**APPENDIX V  
UPLAND DISPOSAL FACILITY ANALYSIS**

**PART I: TECHNICAL MEMORANDUM  
THEA FOSS/WHEELER-OSGOOD WATERWAY  
SEDIMENT TRANSLOADING FACILITY SITING EVALUATION  
AND DESIGN/PERFORMANCE STANDARD ANALYSIS  
PREPARED BY  
COSMOPOLITAN ENGINEERING GROUP,  
ANCHOR ENVIRONMENT, AND  
KPF CONSULTING ENGINEERS**

**Technical Memorandum:**  
**Thea Foss / Wheeler-Osgood Waterway**  
**Sediment Transloading Facility**  
**Siting Evaluation and Design/Performance Standard Analysis**

**Figure 2**  
Middle Waterway Peninsula  
Potential Pier and Upland Holding Areas

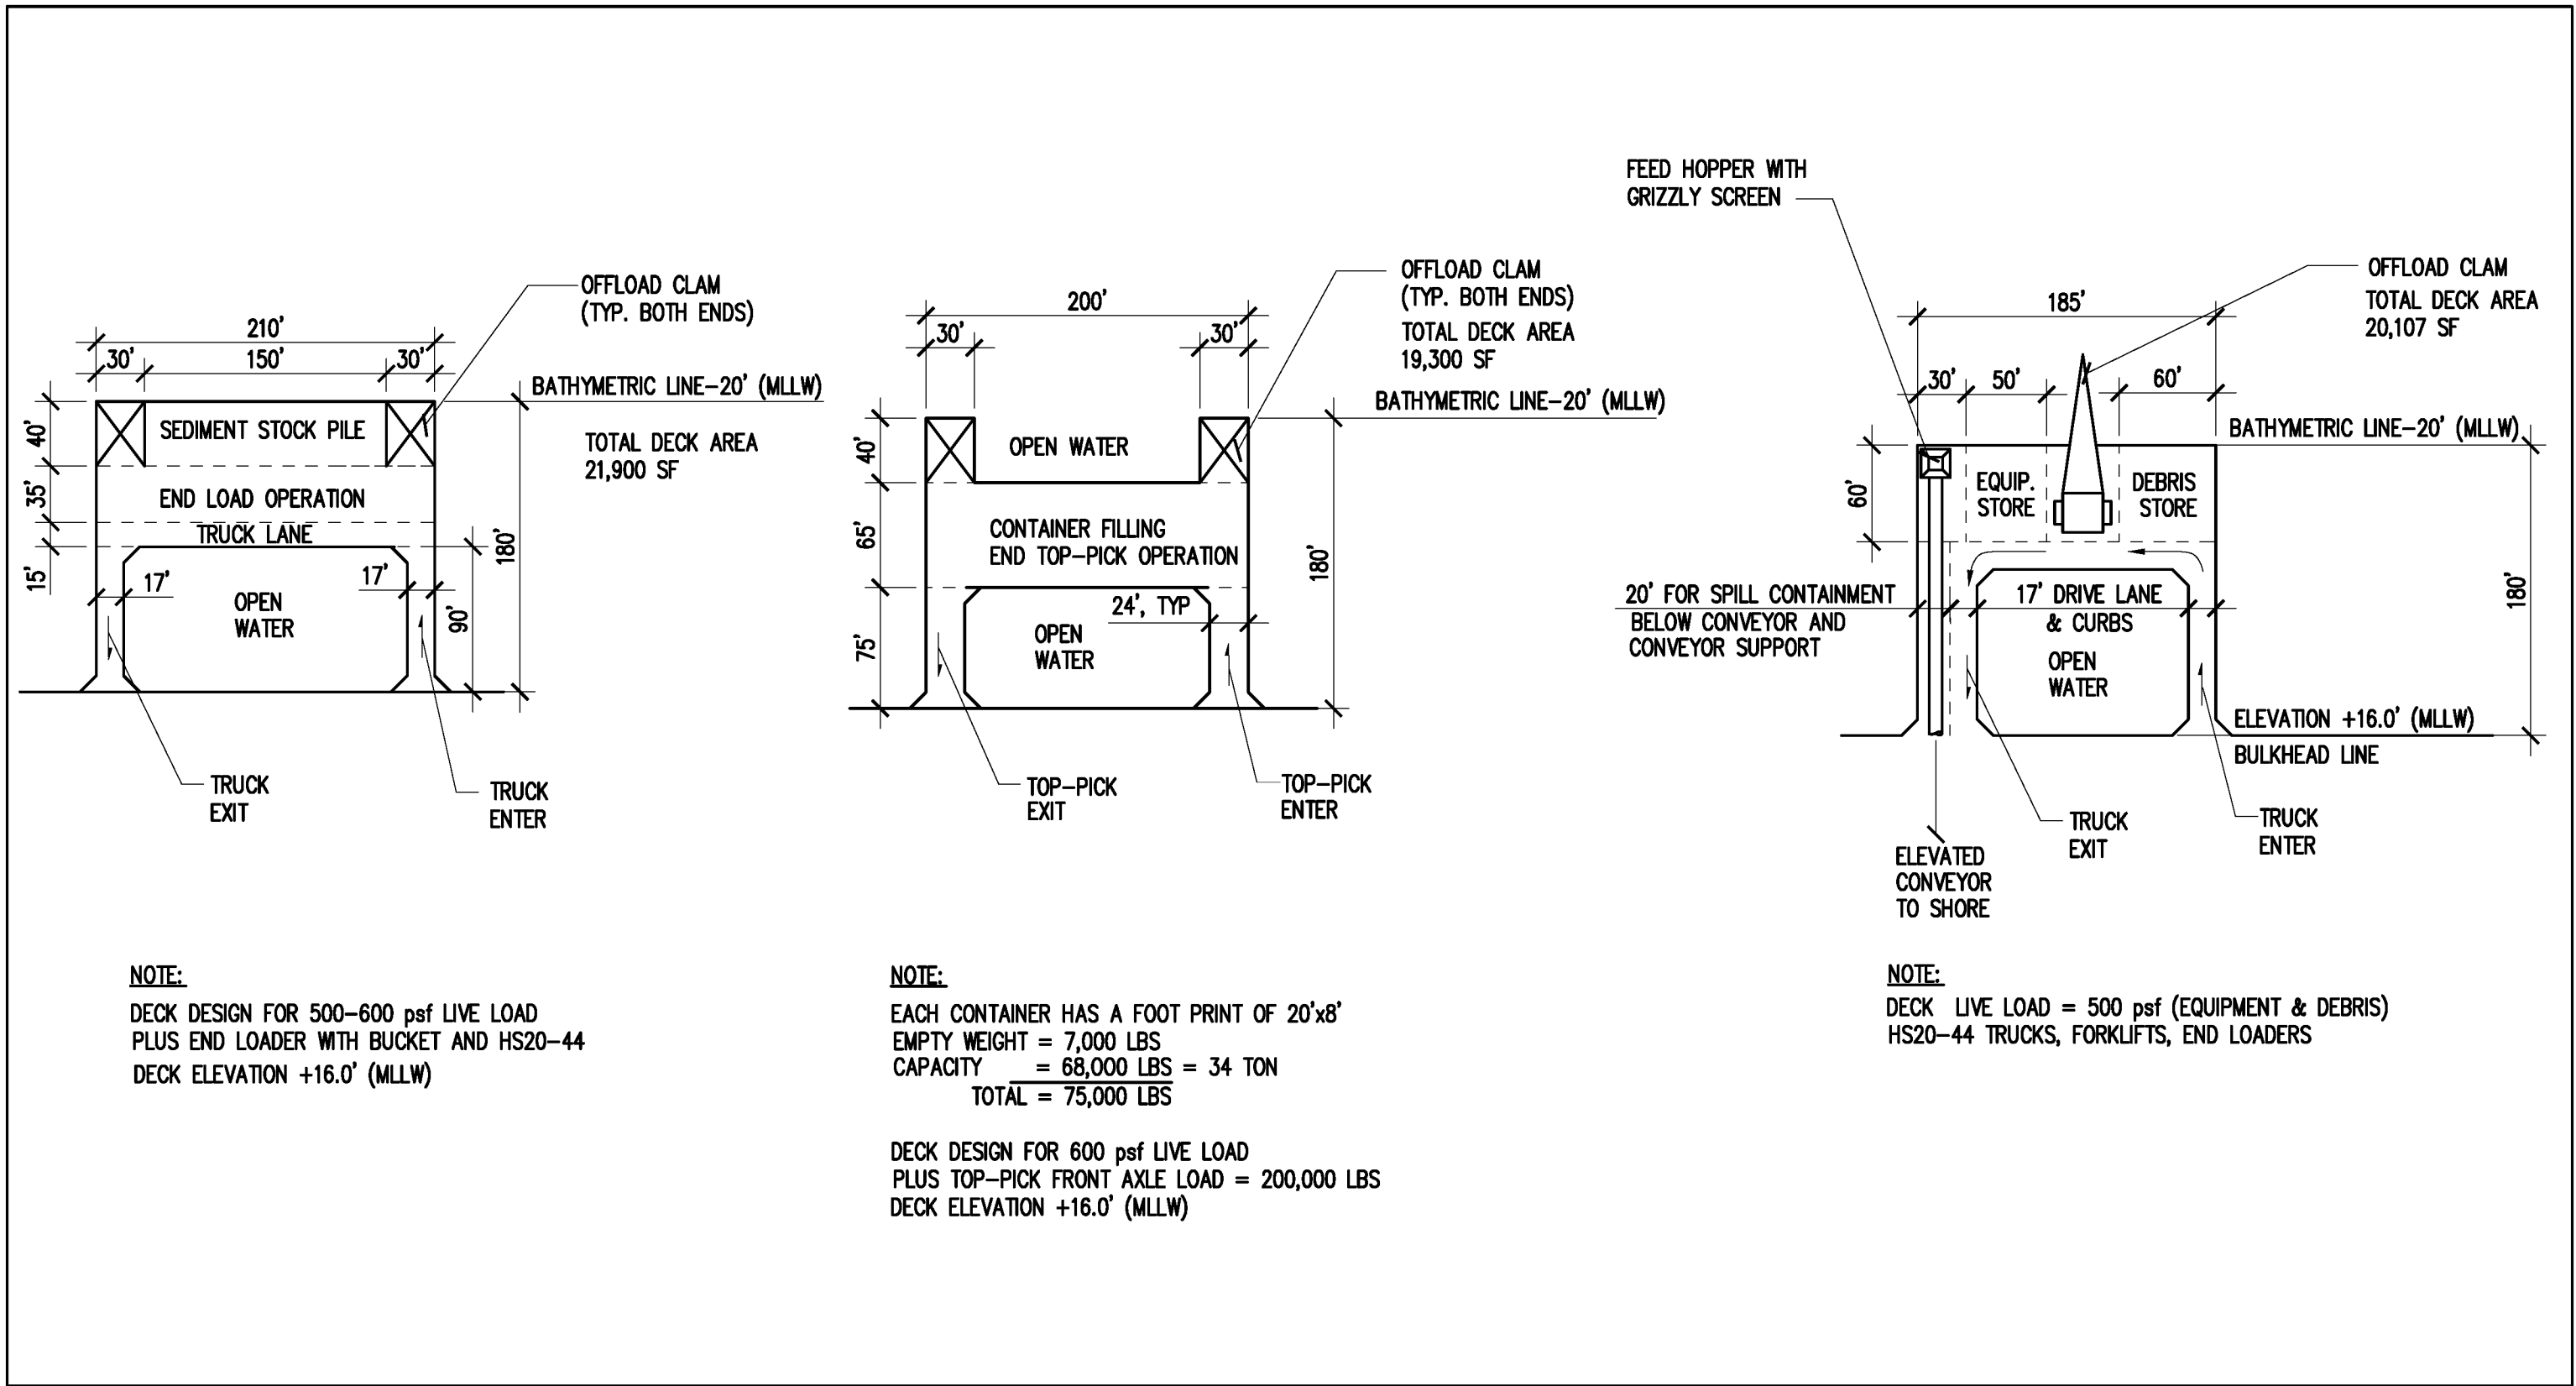
<b>COMMENTS</b>	<b>RESPONSES</b>
13	Figure 2. The required 180' projection of the pier appears to require the pier to be located at the very tip of the peninsula. Please revise with a shaded area consistent with the proposed dimensions.	The location of the pier is presented on Figure 3 of Part II of the Appendix.
	<b>REVIEW OF CITY OF TACOMA UPLAND DISPOSAL FACILITY DESIGN MEMO (DATED DECEMBER 16, 2002)--THEA FOSS AND WHEELER OSGOOD REMEDIATION</b>	
14	<b>General.</b> A preliminary evaluation of the logistics of the rail car operations should be developed as early as possible, to confirm the feasibility of this site.	See response to Comment #2.
15	<b>General.</b> The City shall provide responses to EPA's comments on the City's October 17, 2002 Siting Report on or before it submits the final (35% design) Upland Disposal design. Note: henceforth in the comments "final design" refers to the next submittal of the upland disposal design that will be submitted on January 24, 2003.	See responses to Comments #1 through #13.
